Answers to Anonymous Referee #1 comments

The title has been changed into "A Dynamic Bidirectional Coupled Surface Flow Model for Flood Inundation" combined with consideration of the second comment.

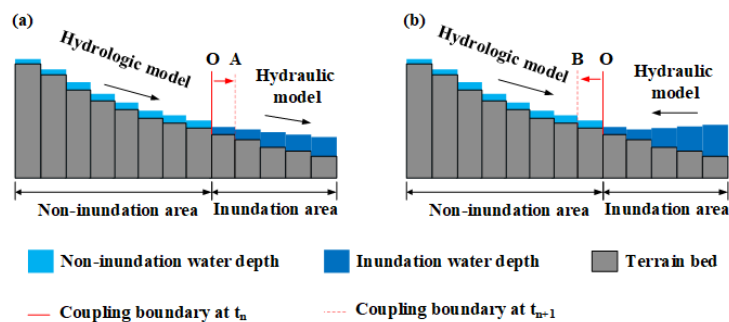
line 212, "is moved to point A", so where was it before?

This indicates the coupling boundary position at the present time step. For the first case, the coupling boundary position will moved to A in the next step, as shown in the following figure(a).

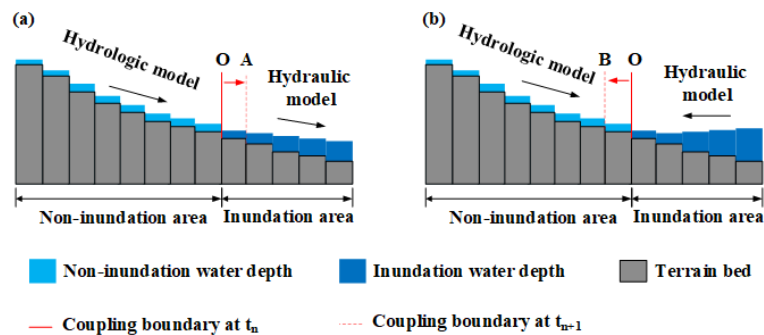
Figures 2 and 4, what is the colour code?

Figure 2 and Figure 4 will be merged into single one as follows:

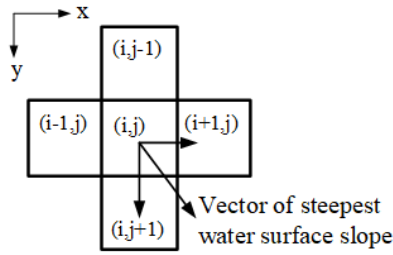
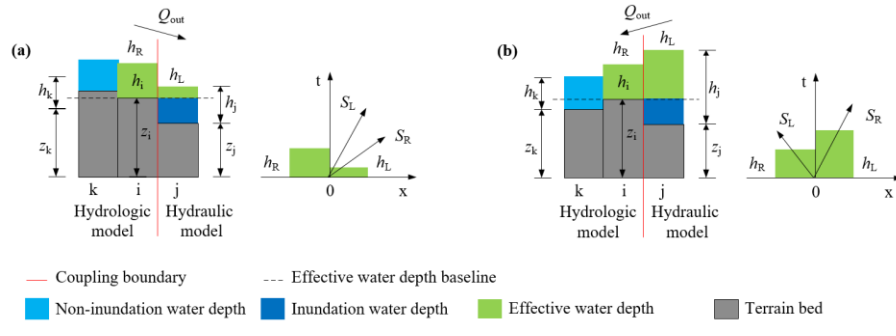
Figure 4, why water cannot flow to the left in the middle figure?

The effects of gravity are that the flow at any point will trend to be in the direction of the steepest water surface slope, as shown in the following figure:

For clarification, figure 4 was modified as follow:
